Intel[®] StrongARM^{*} SA-1110 Microprocessor

Specification Update

April 2001

Order Number: 278259-022

Figure 9-2. Interrupt Controller Block Diagram

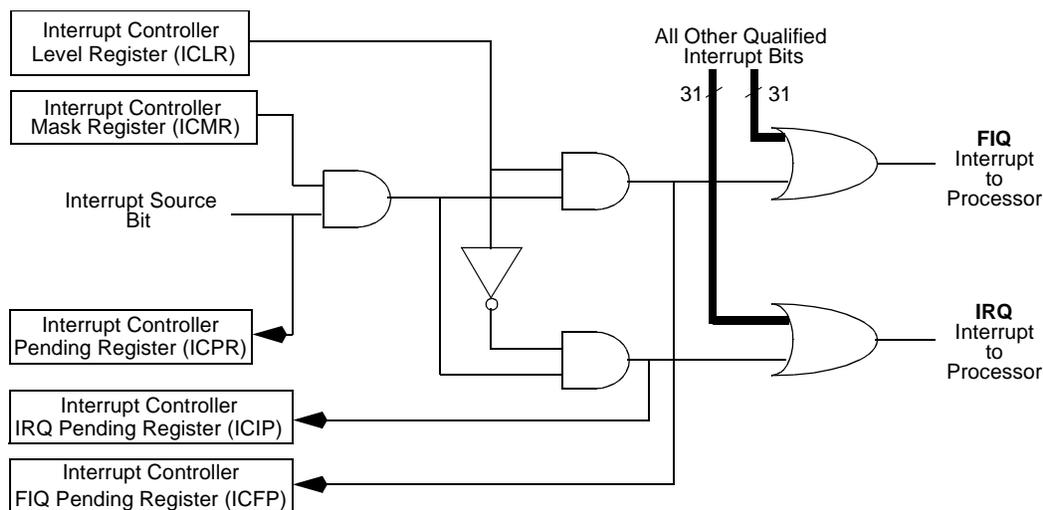
Made the following changes to Figure 9-2.

- Changed Interrupt Level Register to Interrupt Controller Level Register (ICLR)
- Changed Interrupt Mask Register to Interrupt Controller Mask Register (ICMR)
- Changed Interrupt Pending Register to Interrupt Controller Pending Register (ICPR)
- Changed IRQ Interrupt Pending Register to Interrupt Controller IRQ Pending Register (ICIP)
- Changed FIQ Interrupt Pending Register to Interrupt Controller FIQ Pending Register (ICFP)

Figure 9-2 now appears as:

51. DMA Device Address Register (DDARn): Section 11.6.1.1

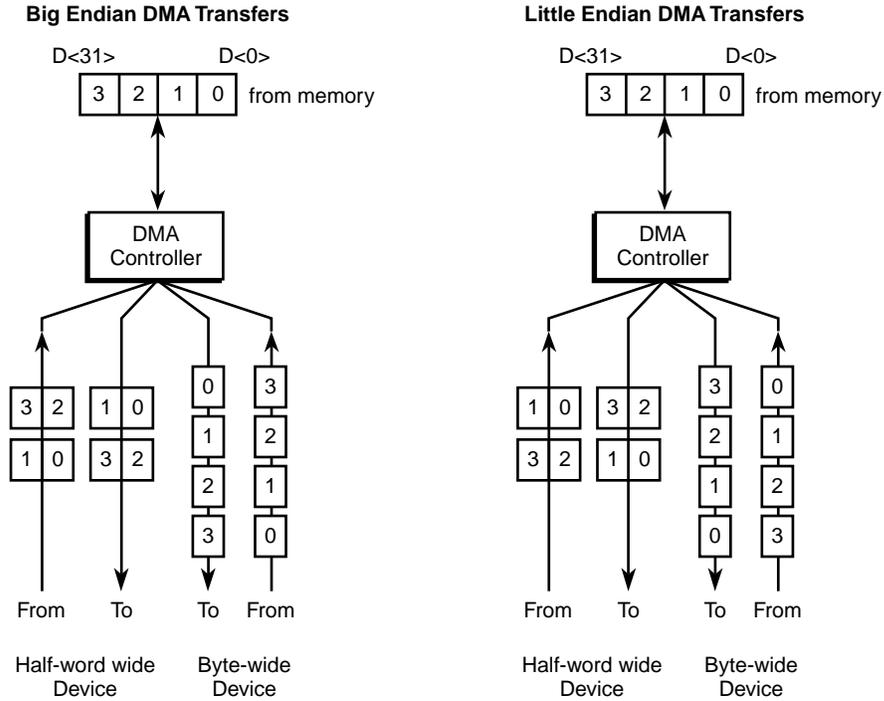
Corrected Figure 11-2.

58. DMA Buffer B Transfer Count Register (DBTBn): Section 11.6.1.6

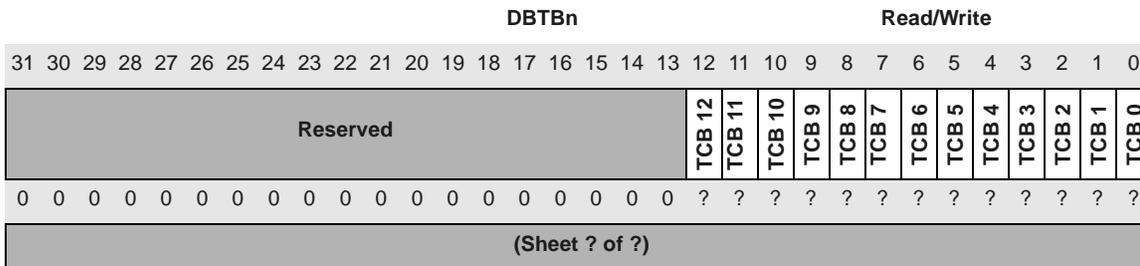
Changed DMA Buffer B Transfer Count register reset values for the Reserved bits to 0.

Figure 11-10. Passive Mode Beginning-of-Frame Timing

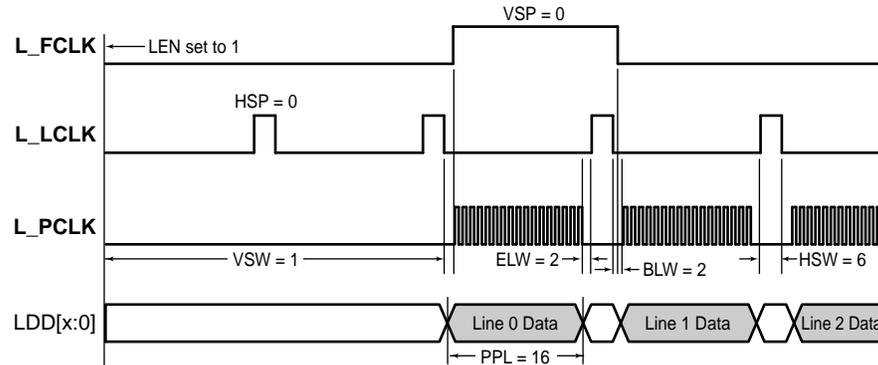
Changed the Notes: in Figure 11-10 to show the range of HSW as 1 to 64, not 0 to 64. The corrected figure is shown below:

Figure 11-11. Passive Mode End of Frame Timing

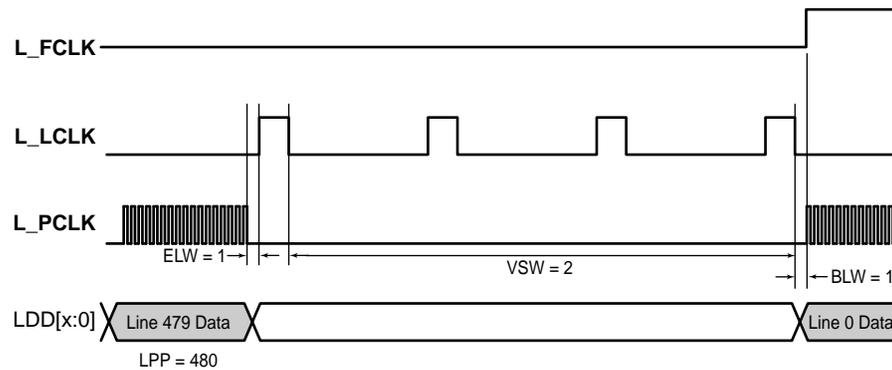
In Figure 11-11 at the location where L_LCLK is deasserted just prior to Line 0 Data, there are two vertical bars depicting BLW = 1. Extended the right vertical bar upward to near L_LFCLK. At this point, changed L_FCLK to show a transition from deasserted to asserted (shown below.)

Also, changed the Notes: in Figure 11-11 to show the range of BLW as 1 to 256, not 0 to 256. The corrected figure is shown below:

Figure 11-13. Active Mode Timing

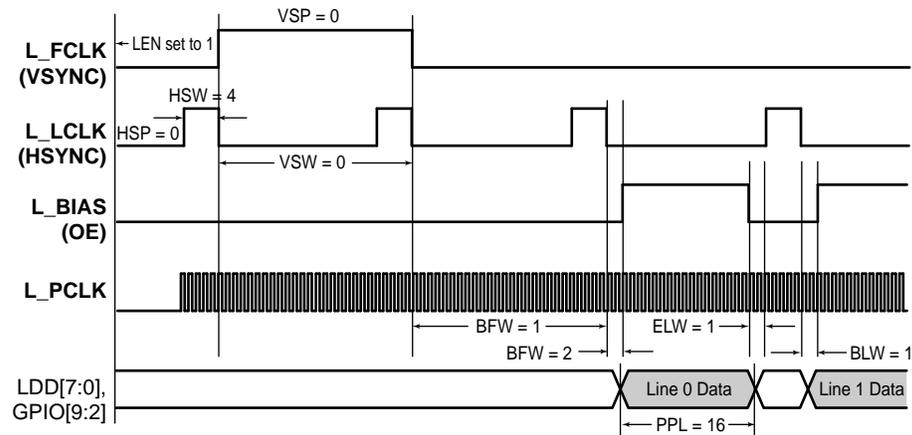
Corrected Notes: in Figure 11-13 to show the range of PPL as 16 to 1024 (not 1 to 1024.) The corrected figure is shown below:
